**Board of
Zoning Appeals**

Agenda (AMENDED)

Board of Zoning Appeals
Thursday, April 21, 2022

**STAFF REPORT
BOARD OF ZONING APPEALS
APRIL 21, 2022**

SITE PLAN

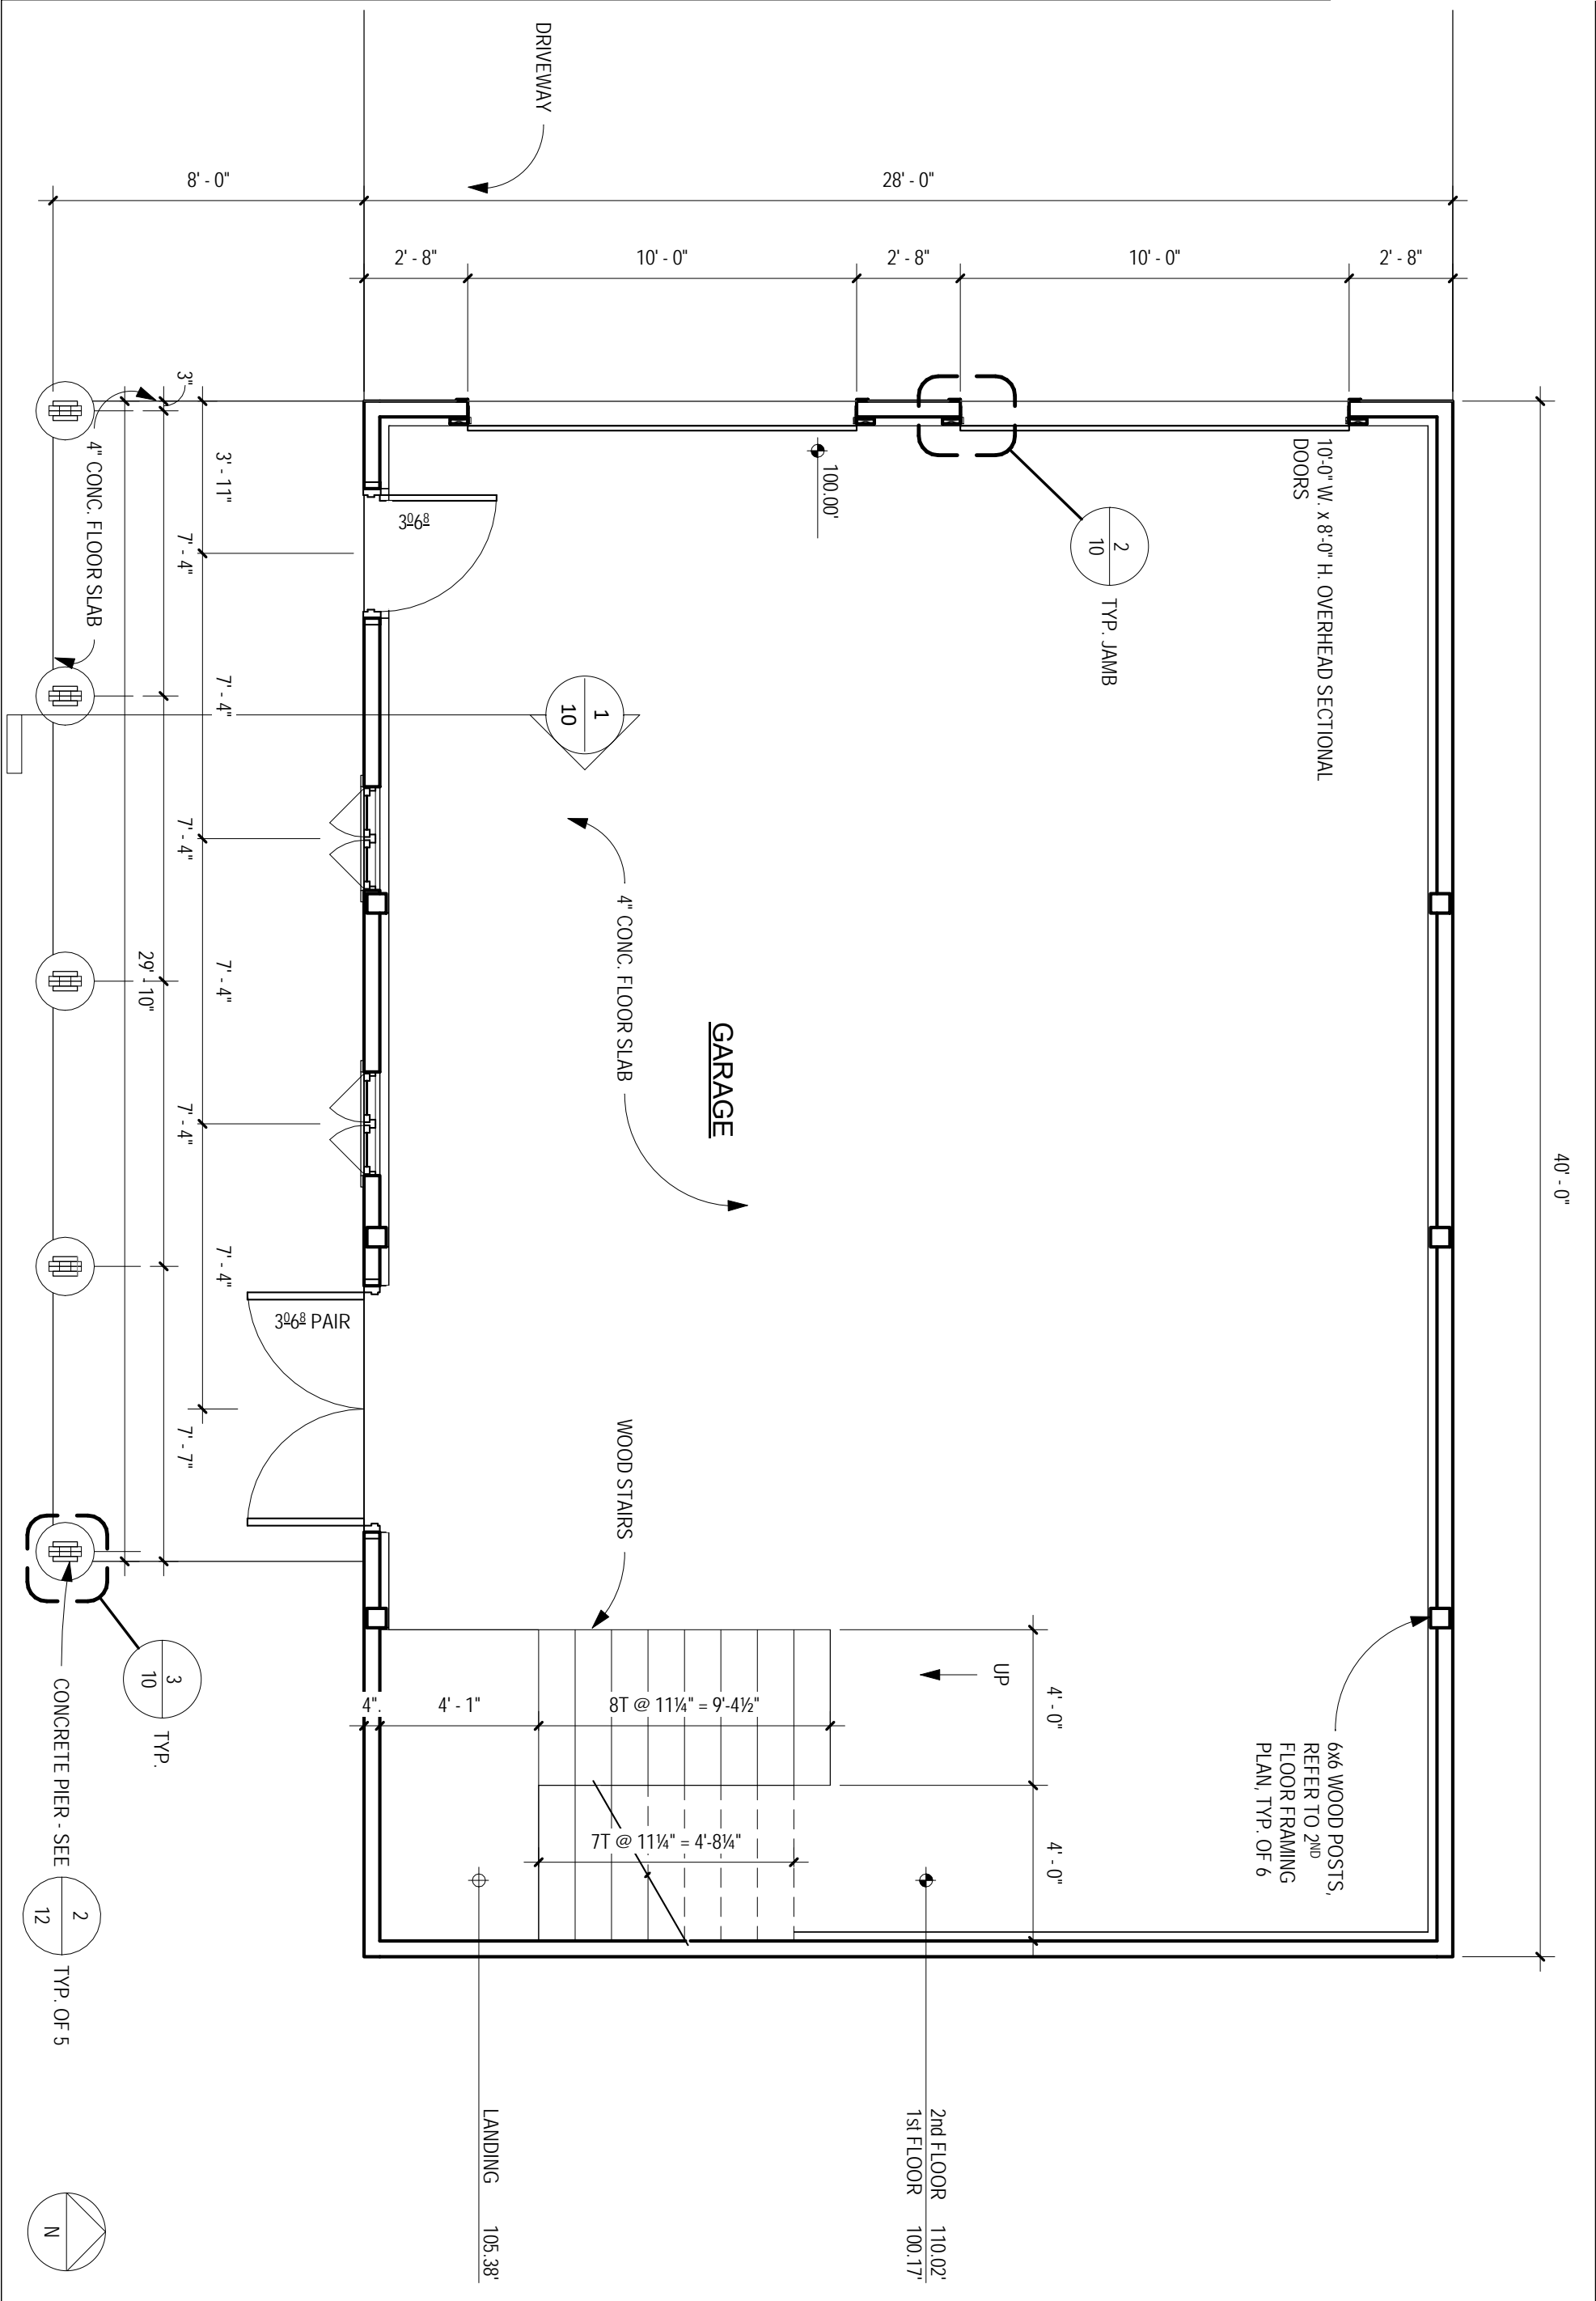
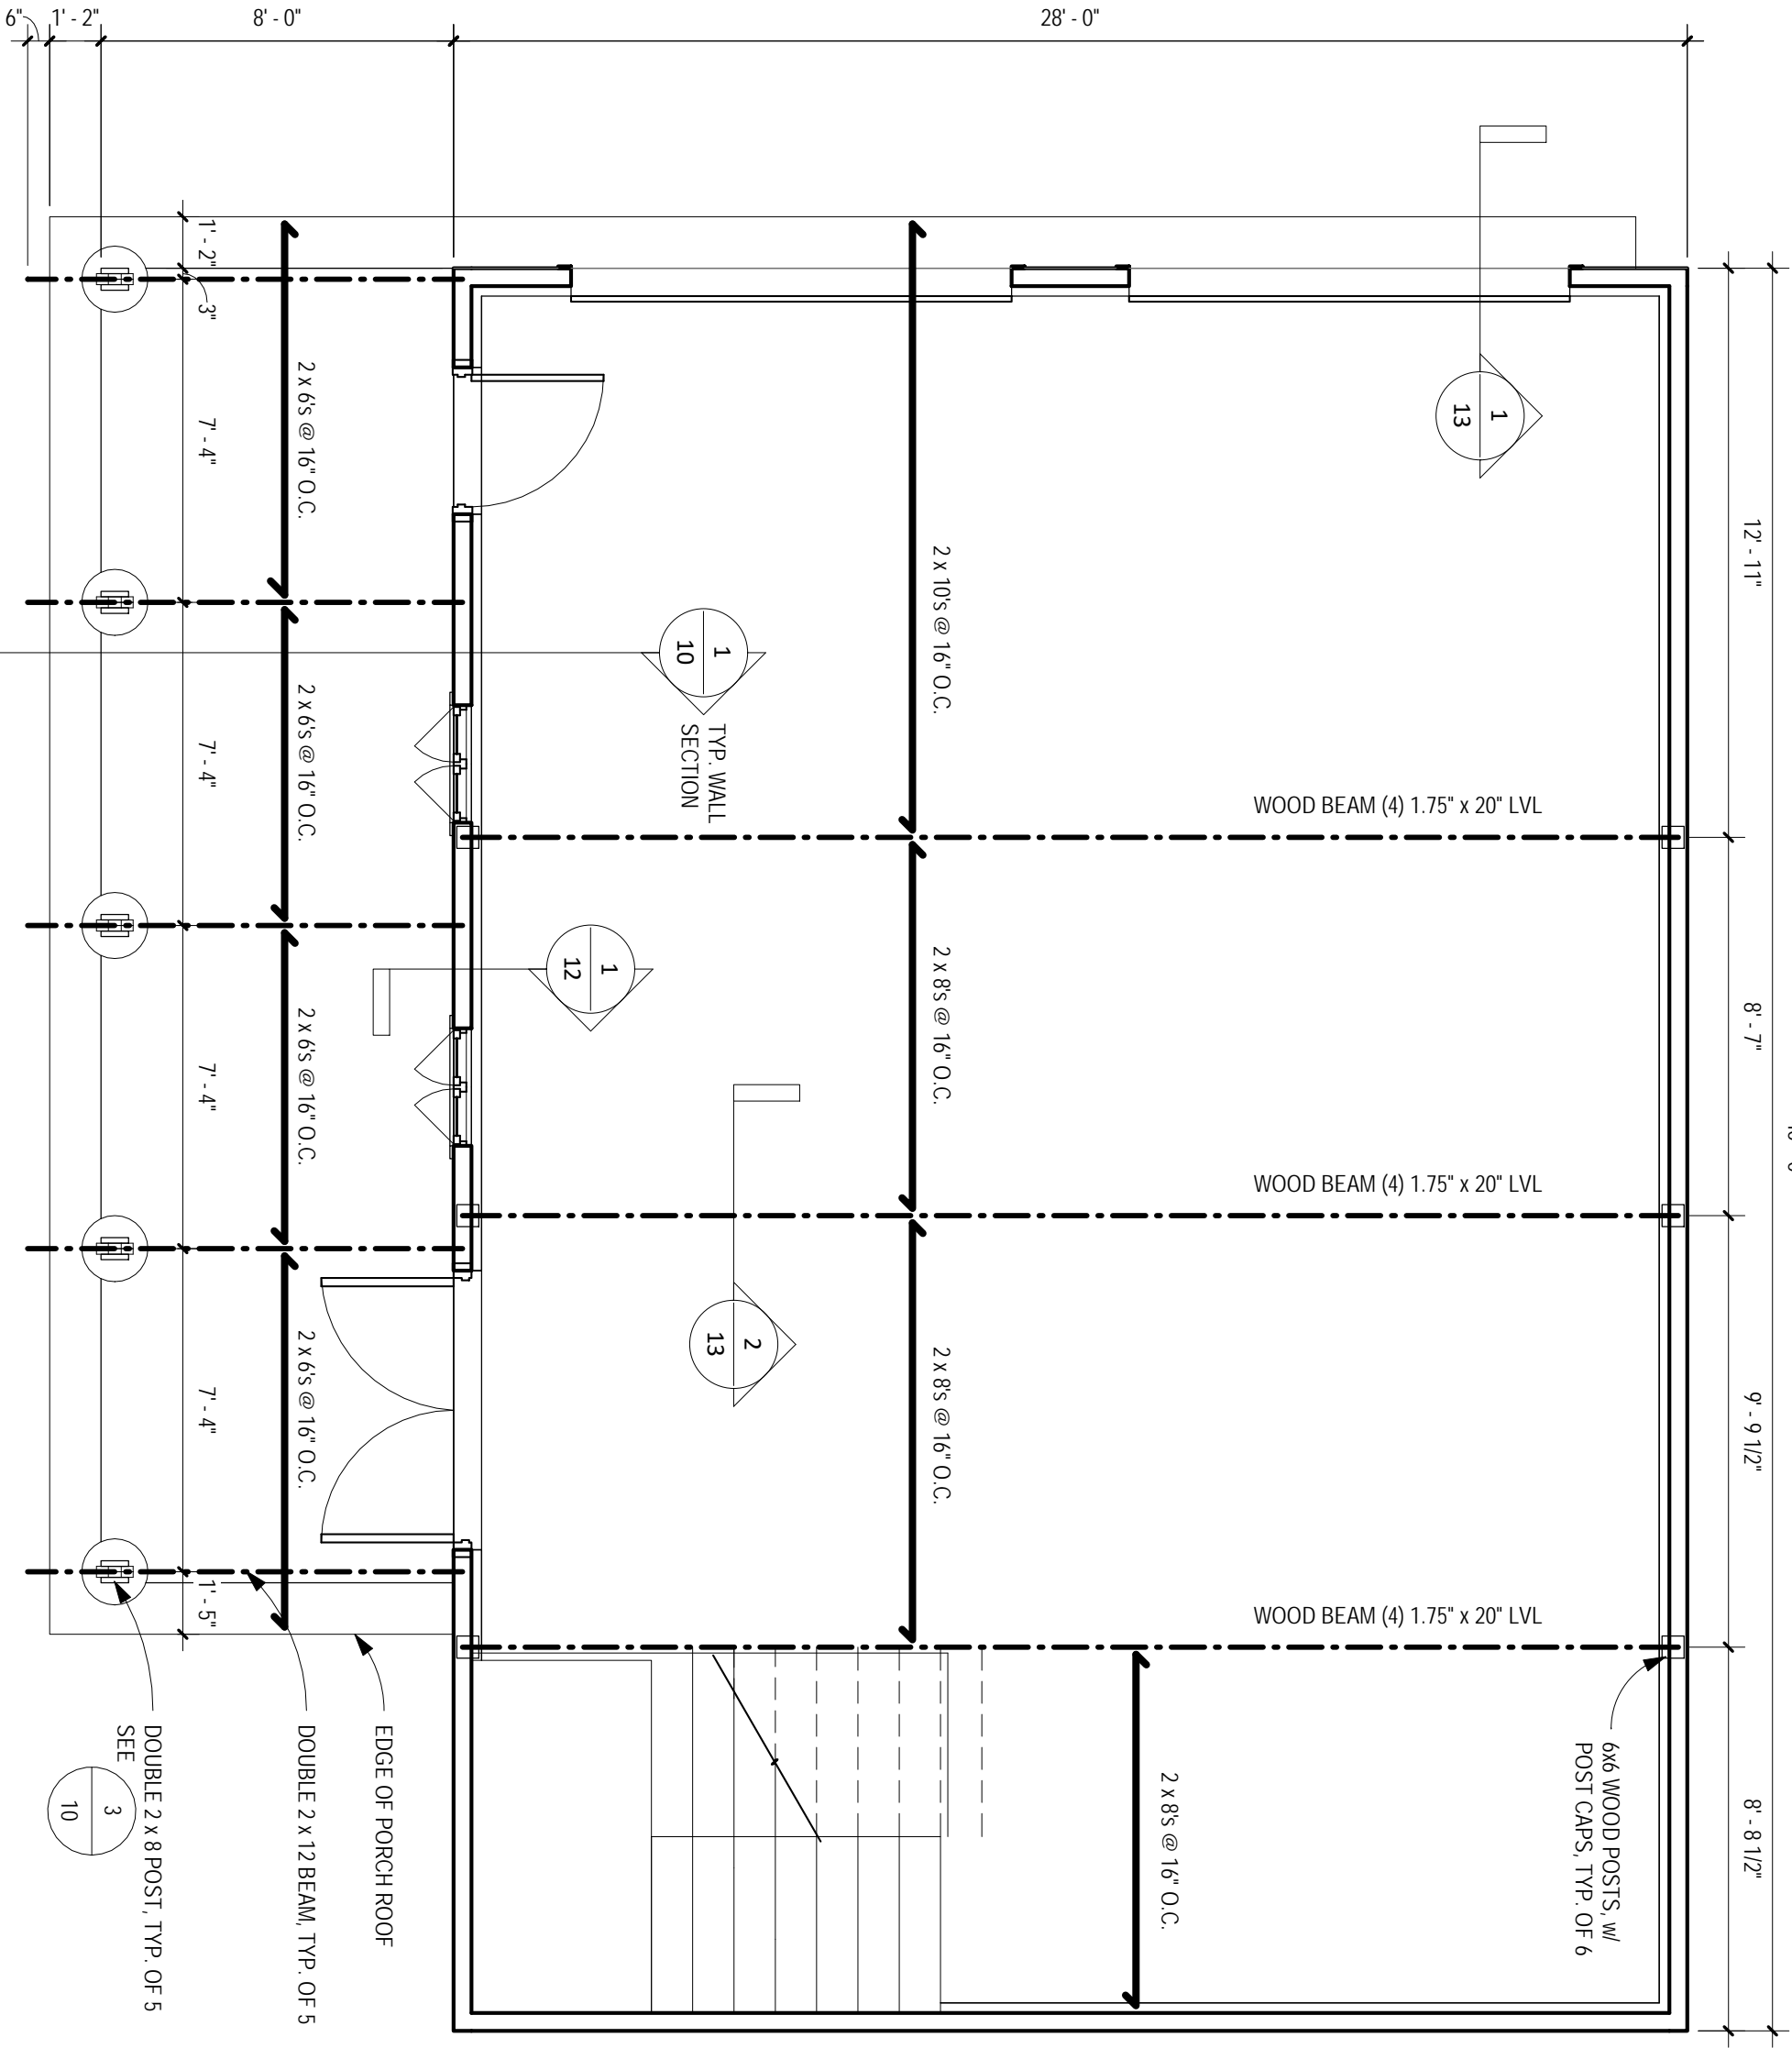
- The garage will be 18-feet in height measured per code; the first story will function as a garage and the second story shall provide storage space as previously approved. Architecture for the garage integrates with the surrounding buildings and features numerous elements to provide variation on each elevation.

- Access to the accessory building is provided via a shared drive with the two residences north of the site. Plans include a gravel connection from the garage to this shared access drive.

Staff finds that there could be a beneficial use of the property without the variance, but that the proposed variance to permit a slightly larger structure will not impact the character of the neighborhood and is not substantial given the nature of the property and the proposed location. The proposed variance will not adversely affect services, and the proposal is consistent with the general spirit and intent of the Code. Based on these findings, consistent with the provisions of Hilliard Code Section 1121.02(b)(7), staff recommends approval of the increased accessory building size with four conditions:

- 1) That the proposed garage is limited to 18 feet in height, as measured by Code;
- 2) That the gravel driveway be permitted as previously approved;
- 3) That the existing accessory structure be removed before or at the time of completion of the new accessory structure; and
- 4) That a zoning certificate and required permits be obtained prior to construction.
